January 14, 2014

SUBJECT: STORM WATER MANAGEMENT POND ISSUE NEAR HIGHLAND PLANT
SMITH RANCH URANIUM *IN SITU* RECOVERY FACILITY, LICENSE
SUA-1548, POWER RESOURCES, INC., CONVERSE COUNTY, WYOMING

Figure 1 – Location of Ponds

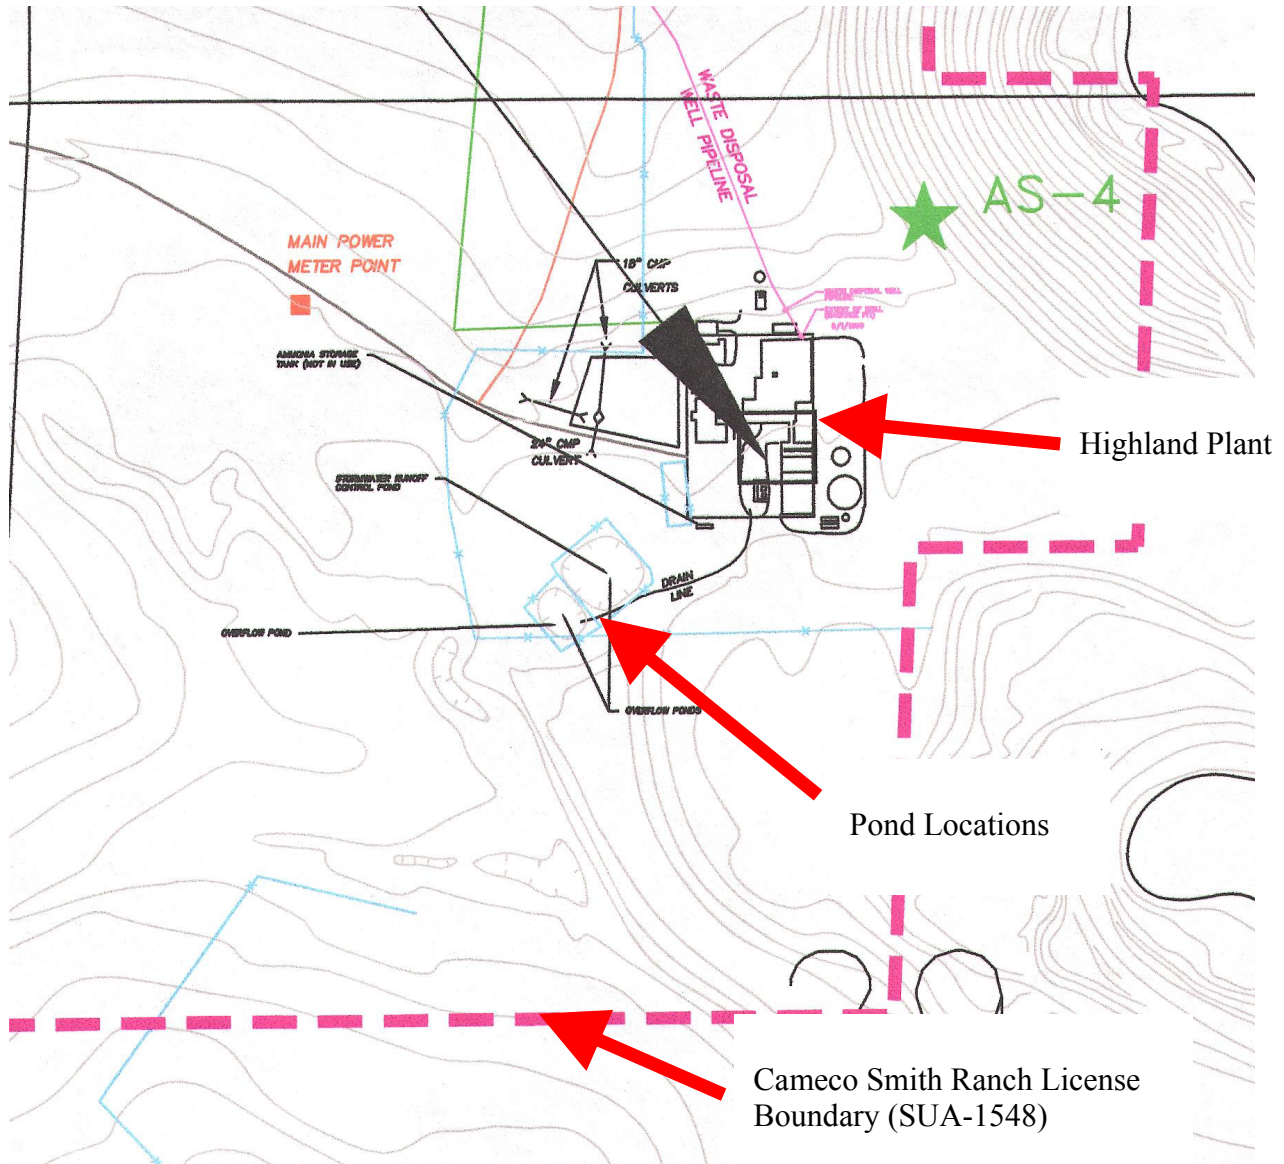
On September 24, 2013, an NRC inspector visited two ponds located near the Highland CPF. The location of the Highland CPF and the ponds are shown on Figure 1. The inspector toured and surveyed the two ponds and found the radiation levels of one pond to be 80 microRoentgens per hour ($\mu\text{R/hr}$) at the edge of the pond liner. The background in that area was found to be approximately 15 $\mu\text{R/hr}$. This reading indicates radioactive contamination is present within the pond. The outside edge of the second pond area had no discernible radiation above background. The ponds are located within a fenced area with a locked gate. The inspector also observed a pump house that appears to contain equipment necessary to move liquid to the ponds. The ponds do not appear to be in use currently as uranium in-situ recovery (ISR) operations at the Highland CPF remain on standby. It is not clear if the ponds are necessary to support future ISR operations at the Highland CPF.

As the ponds are located within the current boundary for materials license SUA-1548, the staff asks that Cameco:

- 1) Determine whether the ponds and associated infrastructure (e.g., pump house and piping) are currently being used.
- 2) Determine whether or not the ponds and associated infrastructure are necessary to support future ISR operations at the Highland CPF.
- 3) If the answers to the first two questions are no, Cameco should commit to decommission and reclaim the ponds in a timely manner as required by 10 CFR 40.42.
- 4) If the answer to either of the first two questions is yes, Cameco should identify what, if any actions, are required to continue use of the ponds.
